SYNGENE INTERNATIONAL LTD, VELANKANI TECH PARK, ACCESSIBILITY AUDIT REPORT

PREPARED BY SVADHIN SOLUTIONS

GROUND FLOOR, SYNGENE INTERNATIONAL, VTPL – ACCESSIBILITY OVERVIEW

SIGNAGE

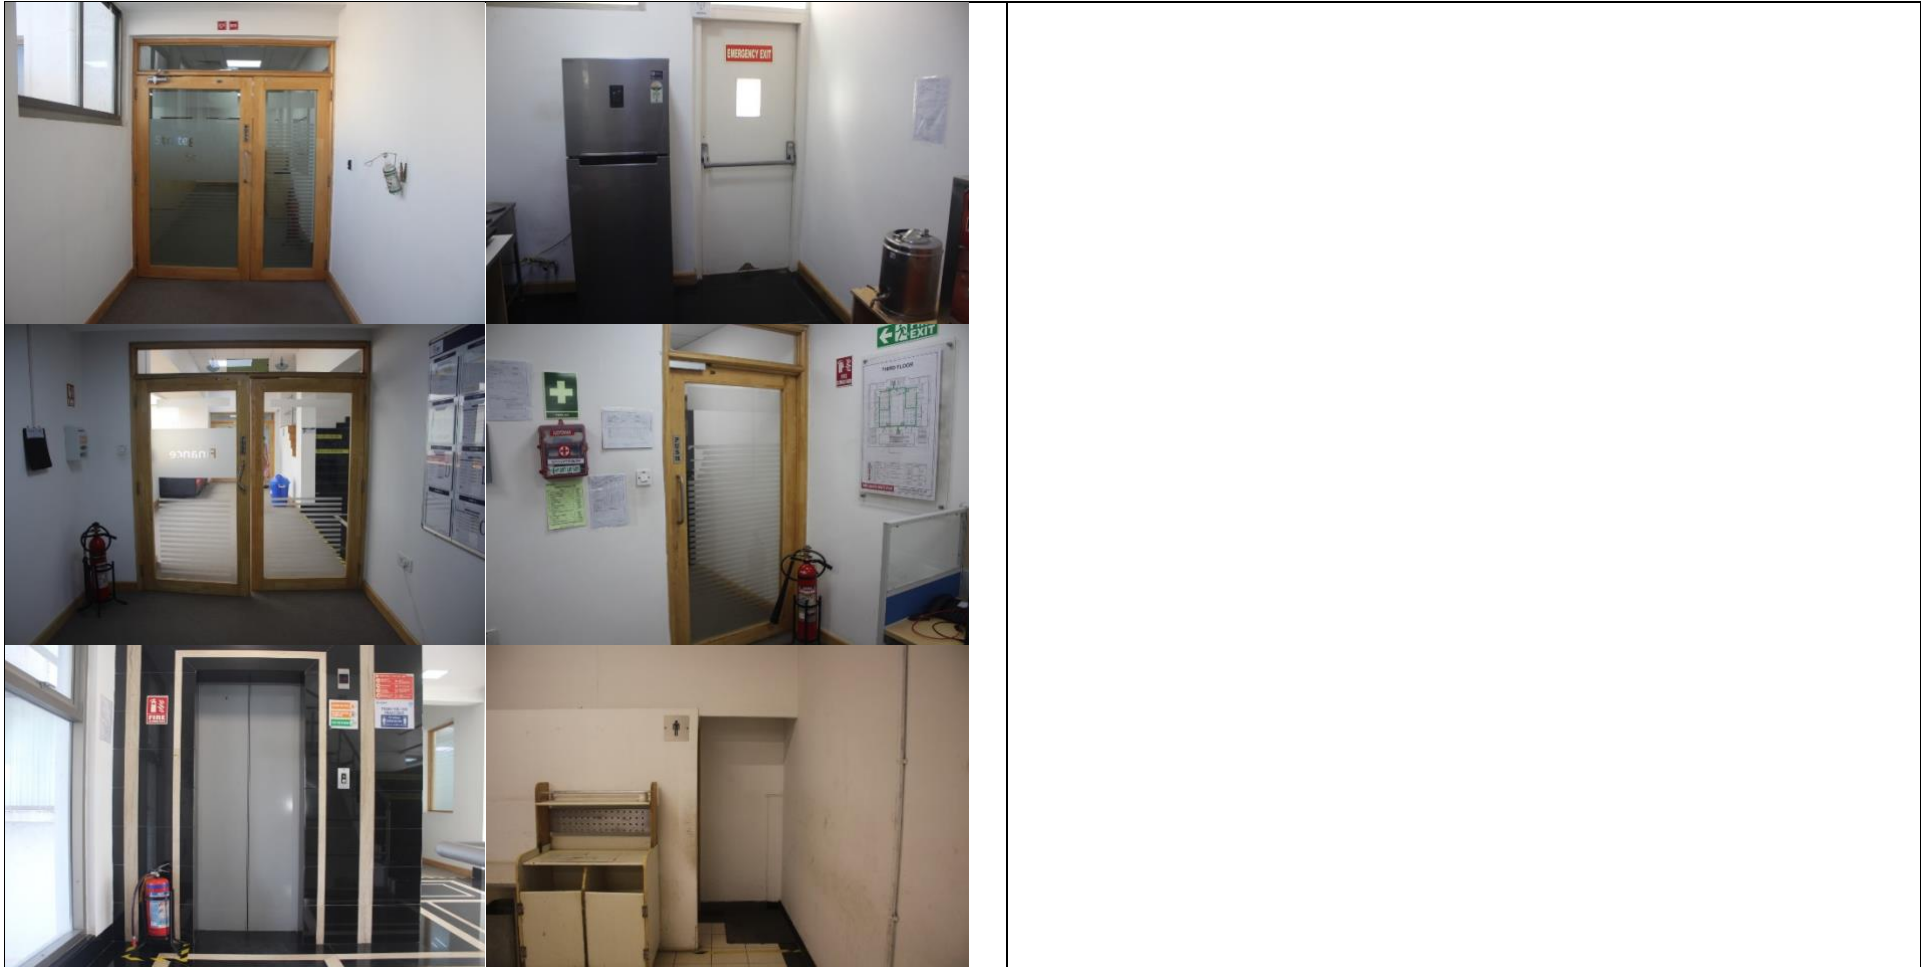
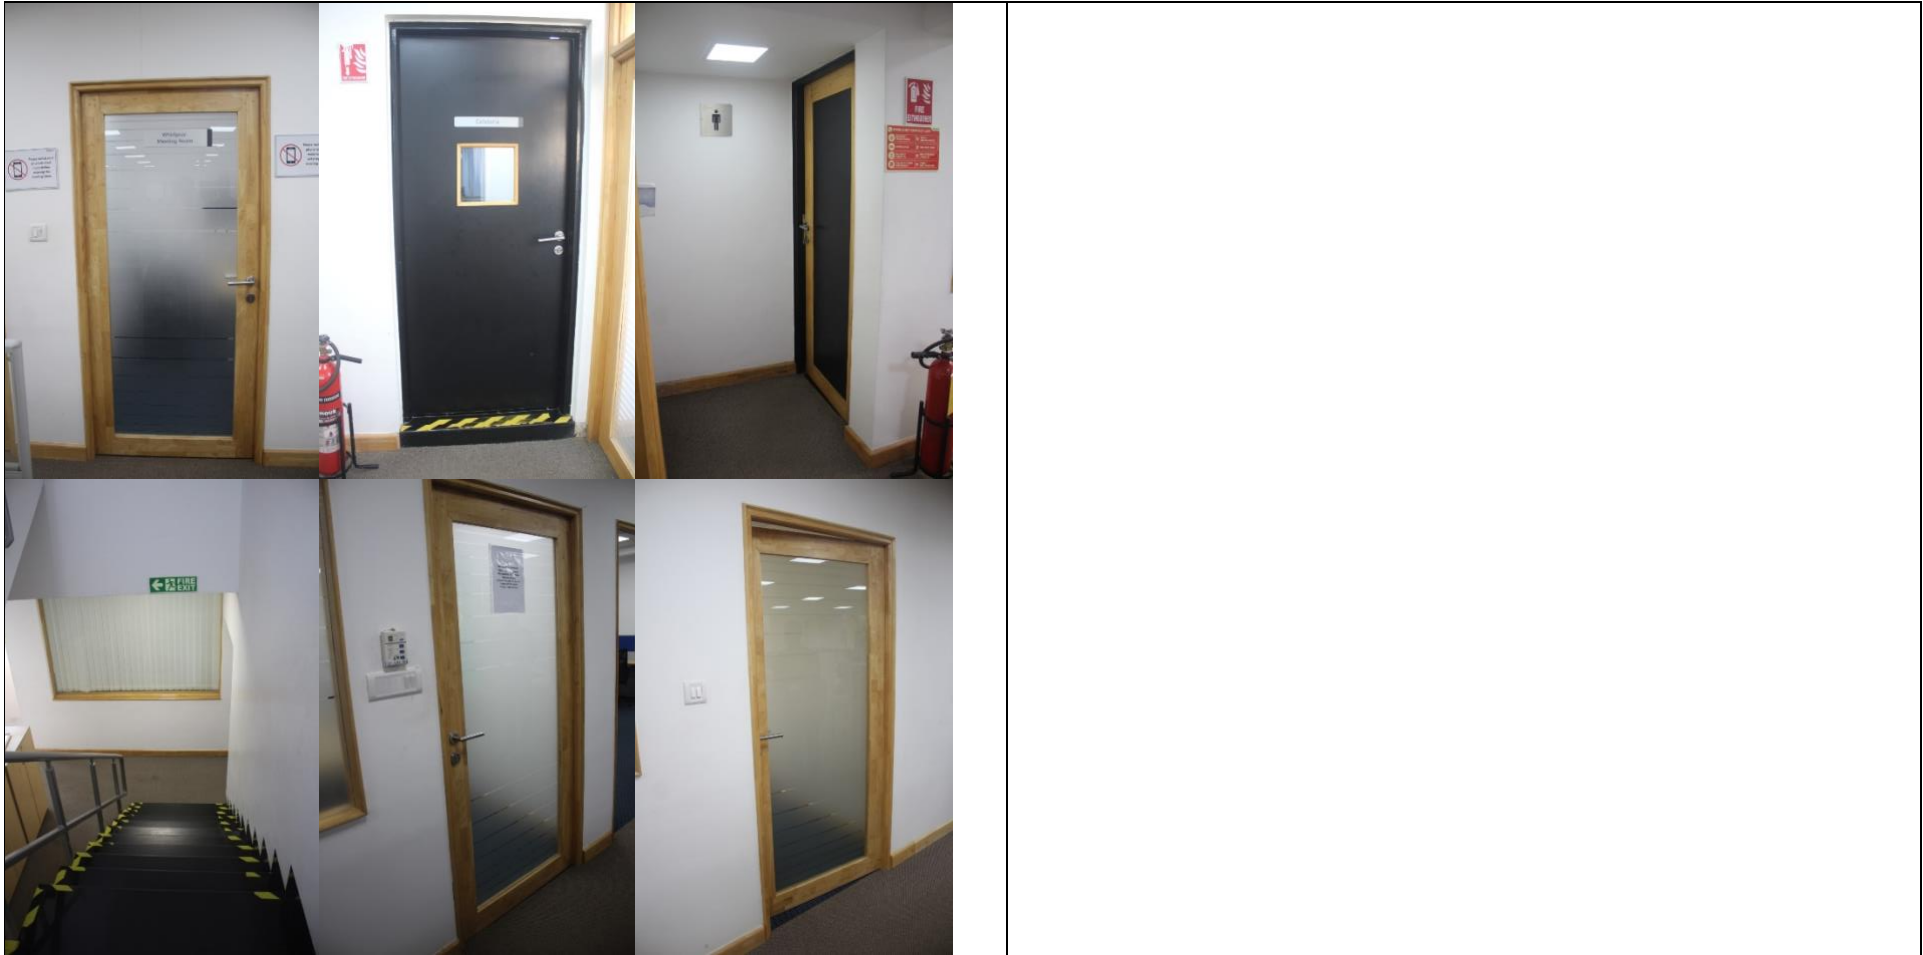
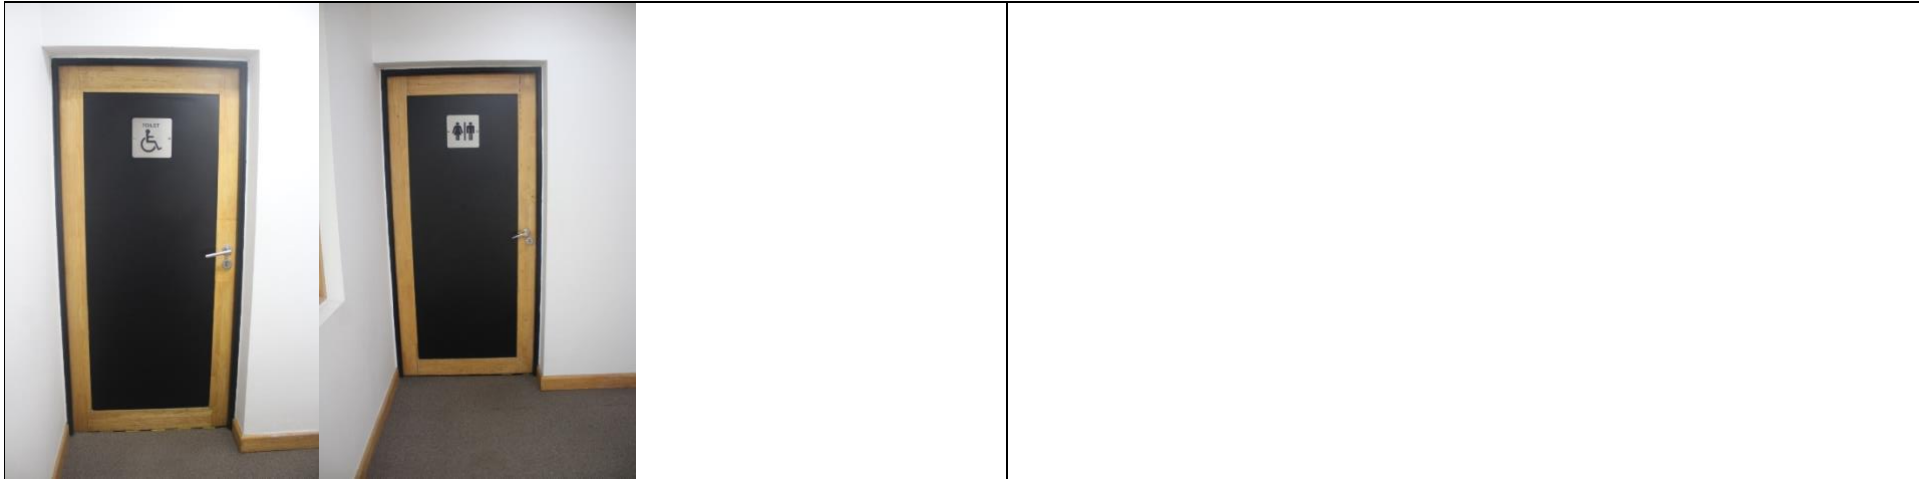
- All existing signage (identification, directional and emergency evacuation signage) throughout the office floors do not have provisions for braille and tactile to support PwDs towards general navigation as well as during an emergency evacuation and are placed at non-compliant to inaccessible heights

- A lot of rooms and areas are missing identification signage completely which makes them hard to identify and navigate to
- None of the floor entrances have accessible signage to support navigation between areas

- There are no accessible signage indicating accessible facilities across the office
- Most of the informational/instructional signage are placed at non-compliant to inaccessible heights with no provisions for braille and tactile and/or audio out provisions making them inaccessible for people with visual impairment

- The accessible restroom signage have no clear content only a pictograph with no provisions for braille and tactile making them non-compliant and hard to read for certain PwDs

PERSONAL CABINS (HALF & FULL)

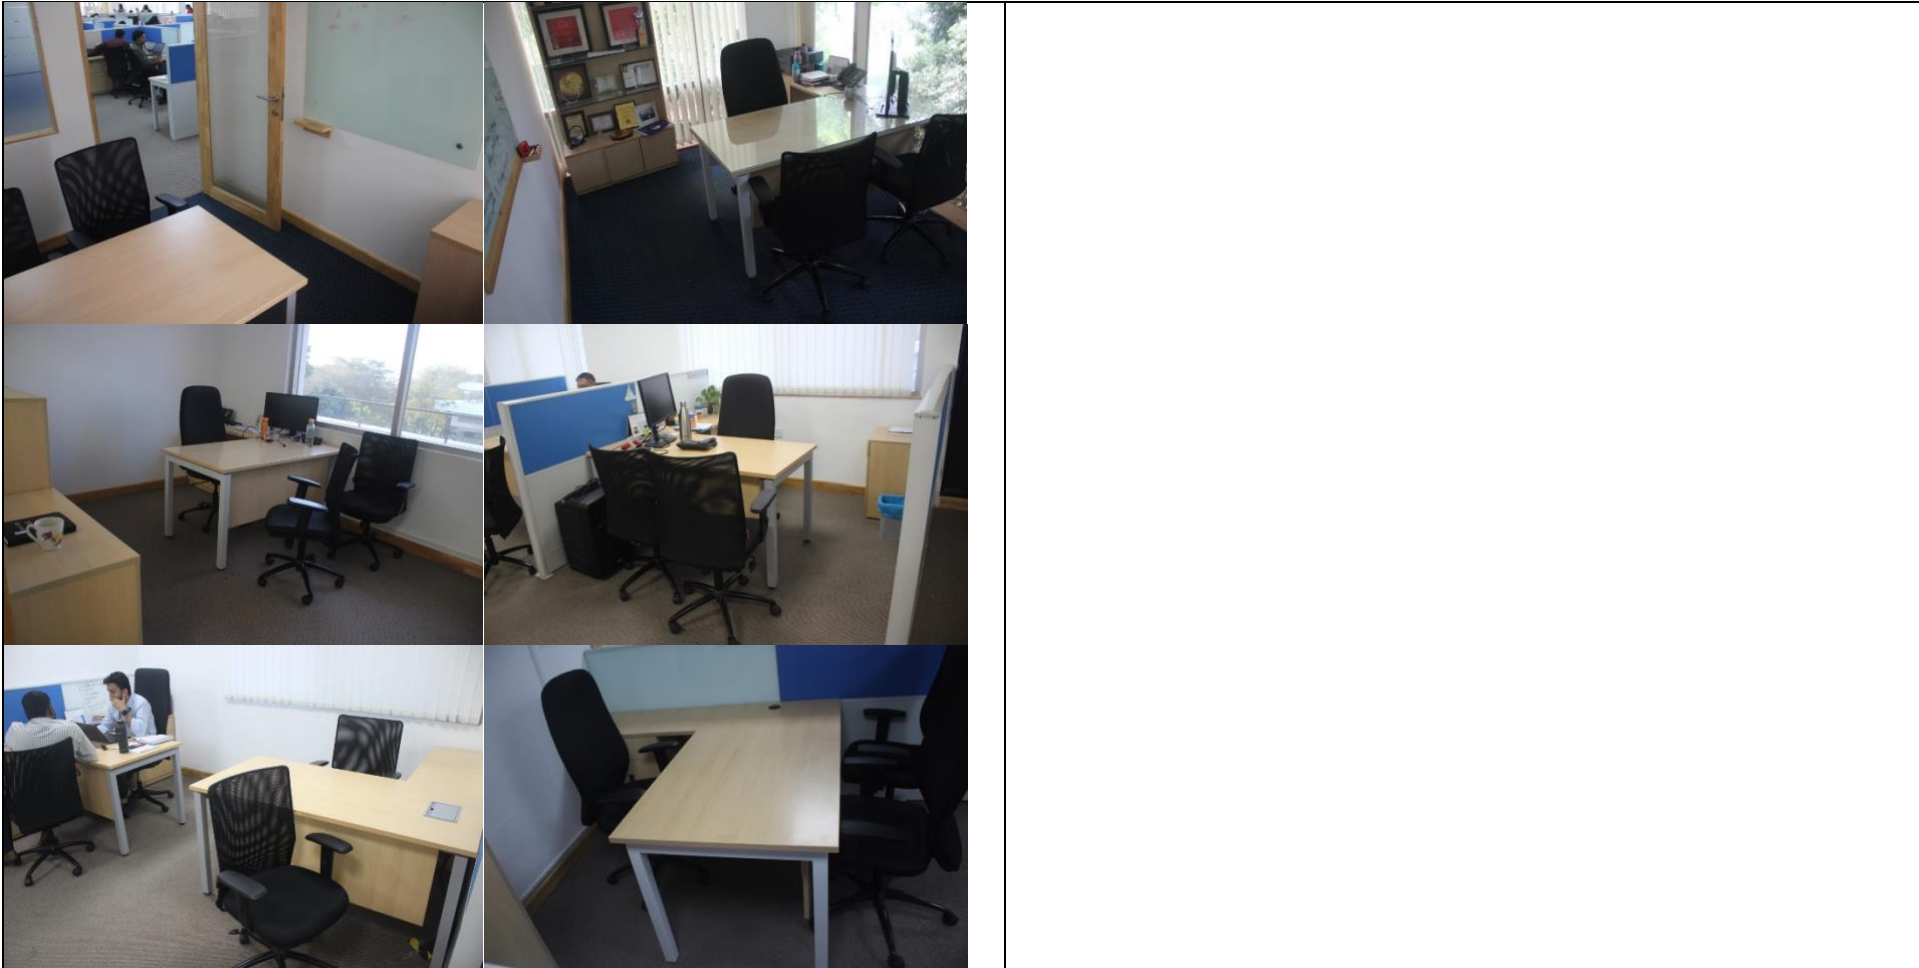
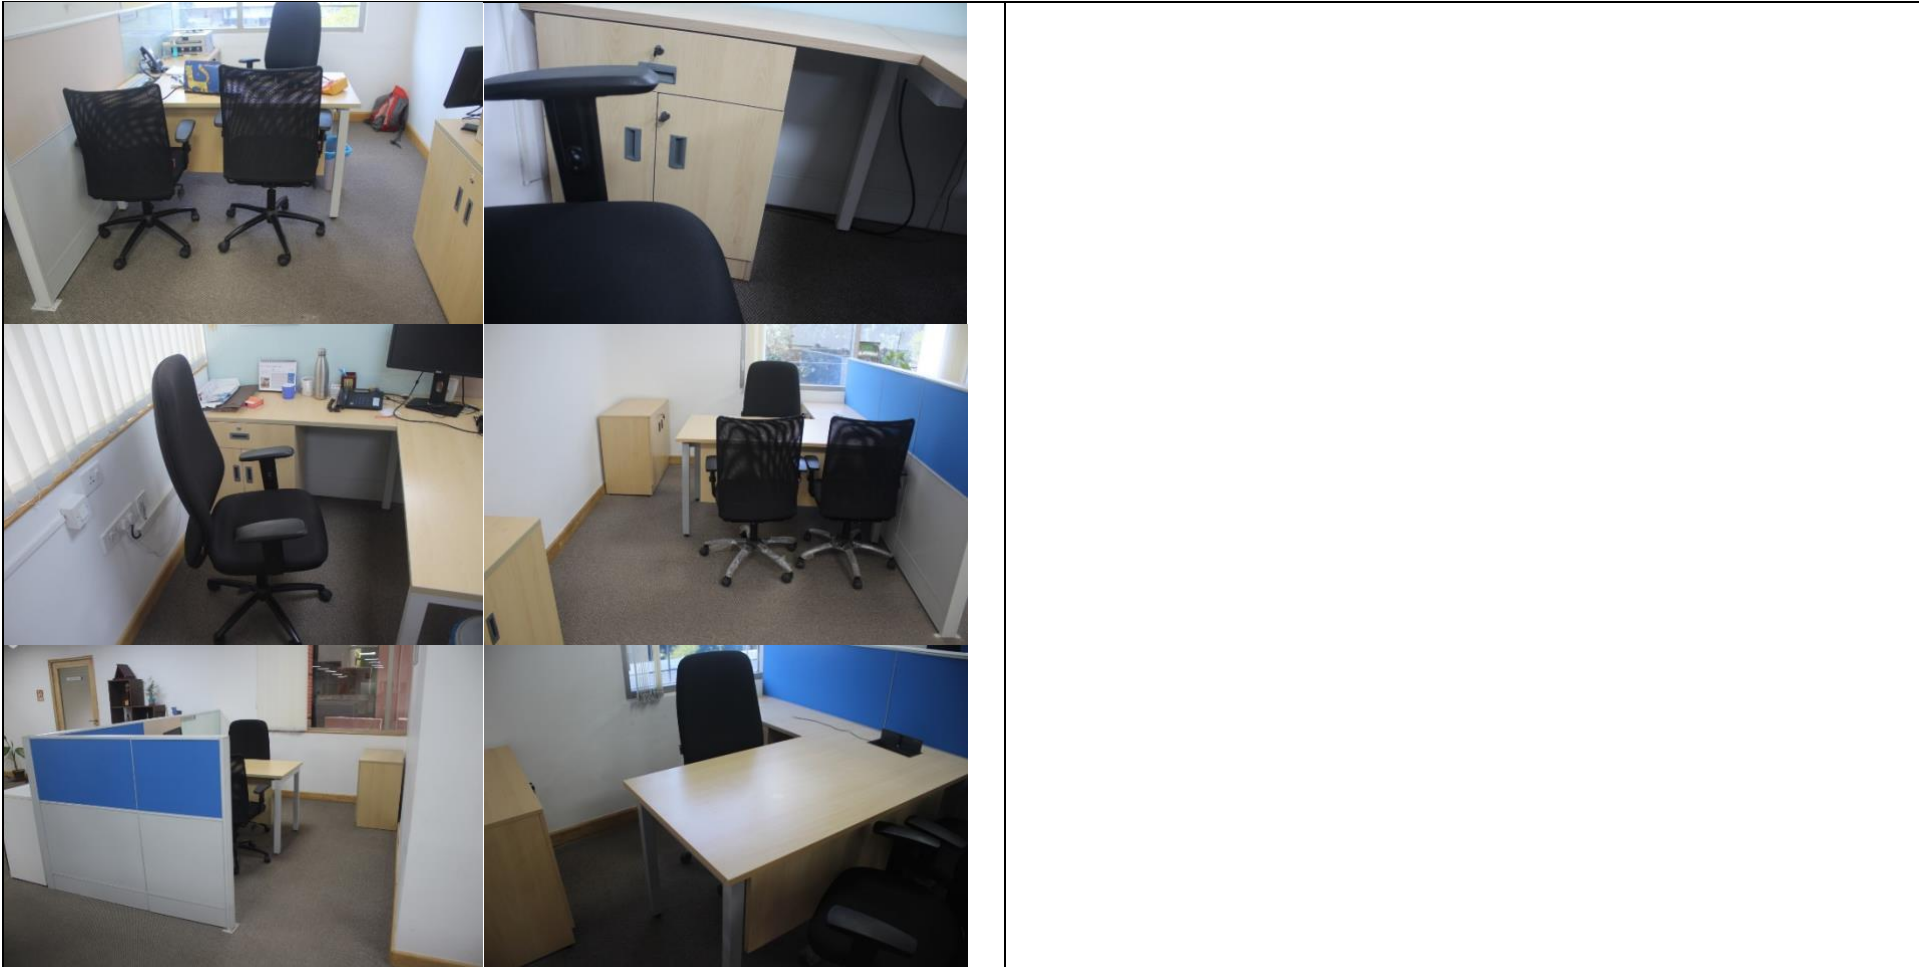
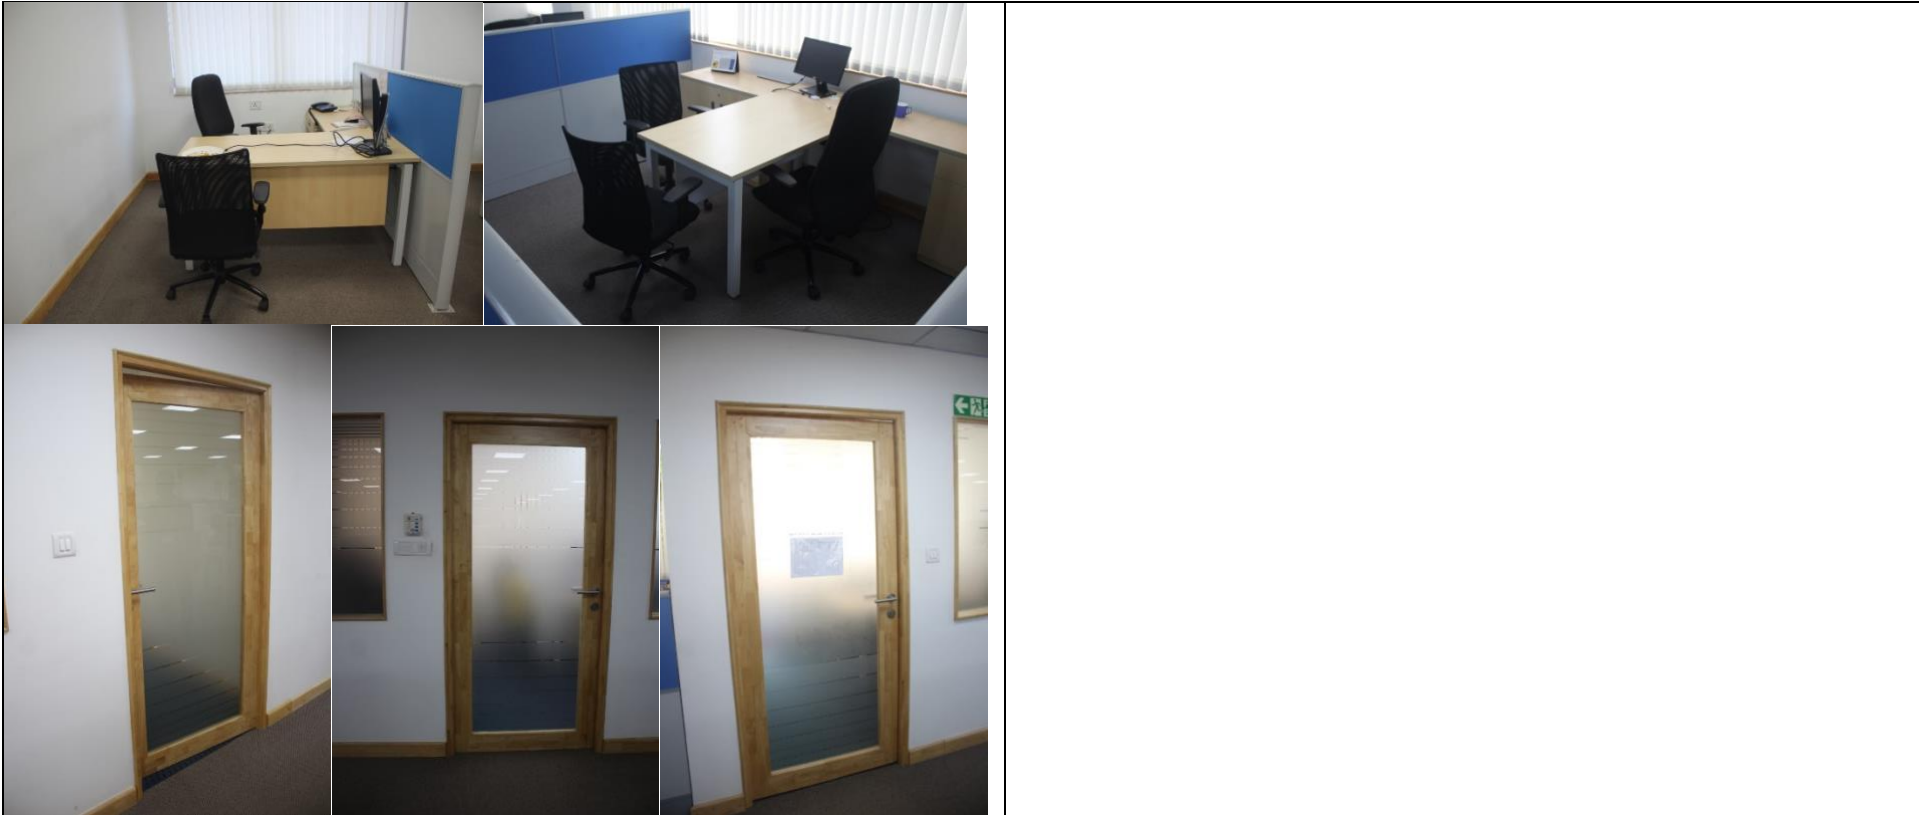
- All the full cabin entry doors have handles placed at non-compliant heights making these entries non-compliant
- Some of the full cabin entry doors have high door tension, some have non-compliant door widths and some have signage placed at non-compliant to inaccessible heights with no provisions for braille and tactile whereas the rest of the full cabins do not have an accessible signage at all making all the full cabin entries non-compliant and largely inaccessible for PwDs
- The ground floor VP cabin and one of the second floor corner full cabin don't have push side door clearances making these entries inaccessible for certain PwDs

- One of the half cabins on second floor as marked in the floor plan has non-compliant entry width
- Most of the personal cabins have non-compliant and/or inaccessible chair clearances as marked in the floor plans (except for the rooms that were locked and not reviewed) and few of them have non-compliant and/or inaccessible entry widths towards the users' side of the table making these cabins non-compliant and hard for PwDs to use

- Few of the personal cabins have marker holders placed along the movement route in which case they may act as projections and can be unsafe for certain PwDs

- All the whiteboards placed in the personal cabins are at heights which reduces the optimal usage area for certain PwDs
- Cable cubbies for two of the personal cabins on ground, first and second floor each are placed at non-compliant depths or inaccessible points

- All the cabins have light switches placed at non-compliant heights with no colour contrast against the background wall making them non-compliant
